Docket Item # 6  
BAR CASE # 2007-0070

BAR Meeting  
June 18, 2008

**ISSUE:** Alterations and addition  
**APPLICANT:** Art Underfoot, Inc.  
**LOCATION:** 1203 King Street  
**ZONE:** KR/King Street Retail

Figure 3: Plat showing proposed addition

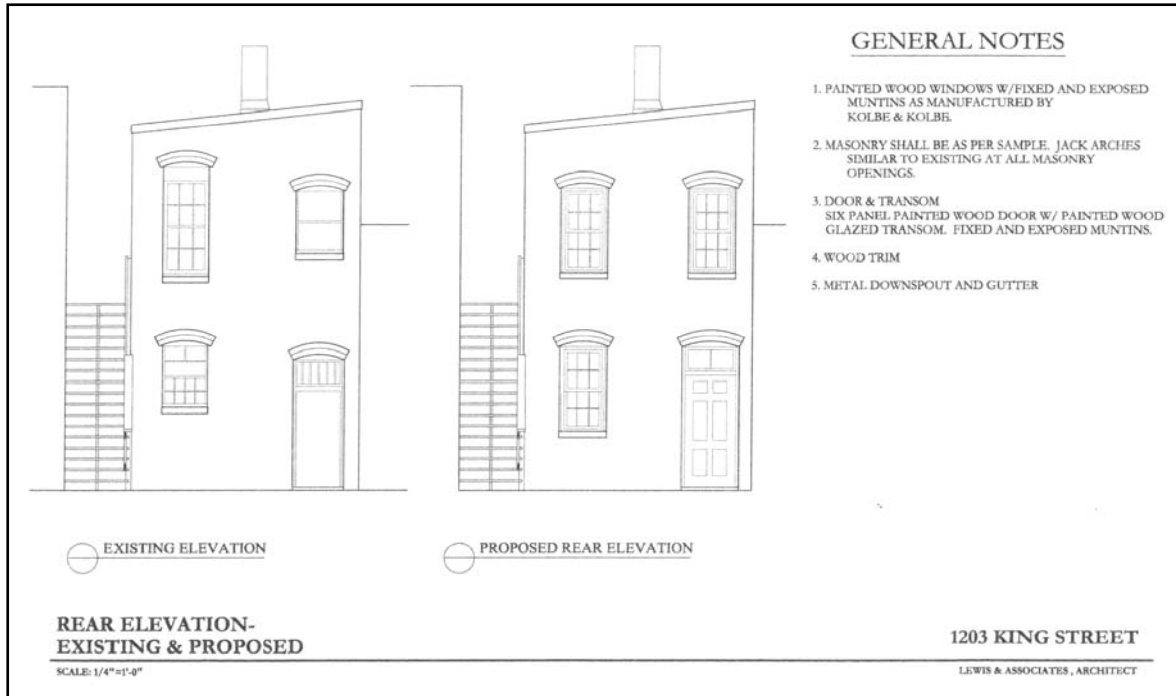
UPDATE: Update: Since the April 16, 2008 Old and Historic Board of Architectural Review meeting, the applicant has prepared new drawings to reflect the proposed addition and the design of the new rear elevation, as well as a revised plat showing the footprint of the proposed addition. The amount of encapsulation of the existing rear elevation remains the same as previously proposed. The existing flounder addition will be retained with only the rear elevation being encapsulated by the rear addition.

The proposed two story addition will have a footprint of approximately 380 square feet and will be clad in brick. Staff reminds the Board that originally the applicant was requesting a one-story addition and is now requesting a two-story addition.

**Figure 4: Drawings showing existing and proposed rear elevation**

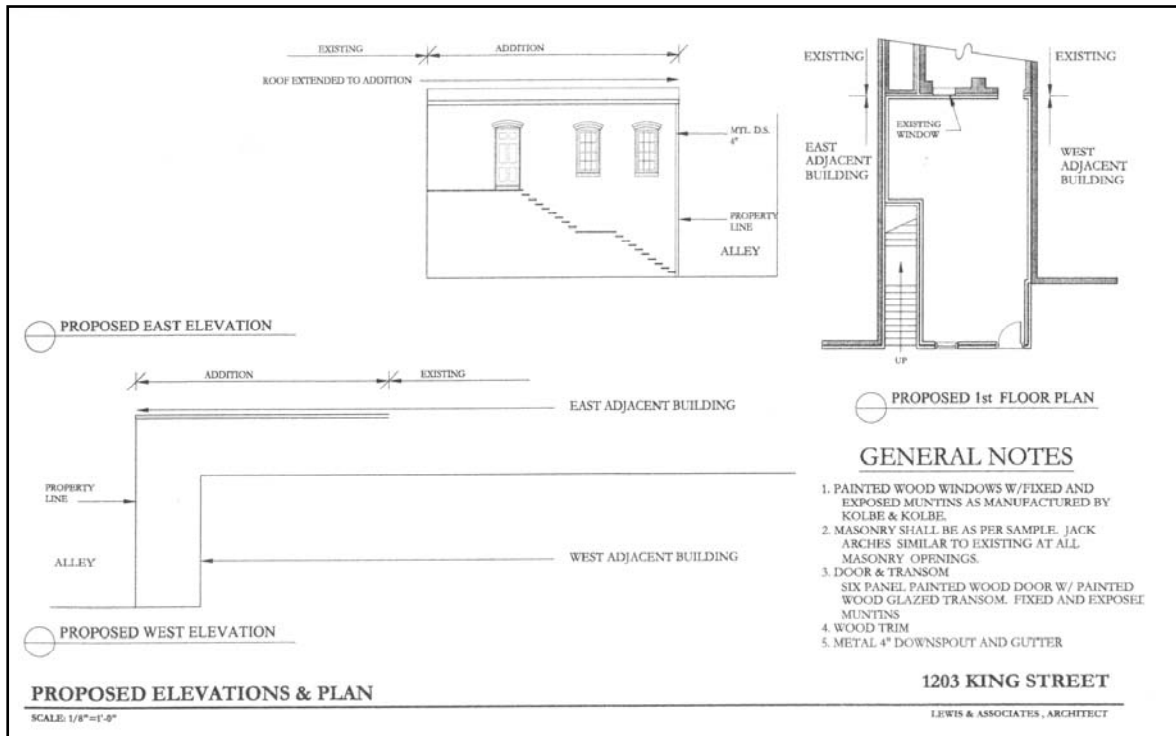
**REASON:** The Board believed that the new rear addition should mimic the existing rear addition and use, for example, brick jack arches over the windows; an appropriate transom; appropriately proportioned windows and no wood shingles. The members agreed that new drawings were needed before the Board could take action.

The design of the addition's rear elevation will mimic the existing flounder design. The new rear (north) elevation will have a two-bay configuration, with a single six-over-six, double-hung wood window and one six-panel wood door with a transom as an entrance. Two six-over-six, double-hung wood windows will be installed on the second floor. All windows will be wood, double-hung, double-glazed, and simulated divided light, manufactured by Kolbe and Kolbe.

The addition will be constructed of brick, to complement the existing brick. The applicant will provide a sample at the hearing. All trim will be wood and new downspouts and gutters will be installed. A standing seam metal roof will be used on the addition. Jack arches will be placed above all windows and doors on the addition.
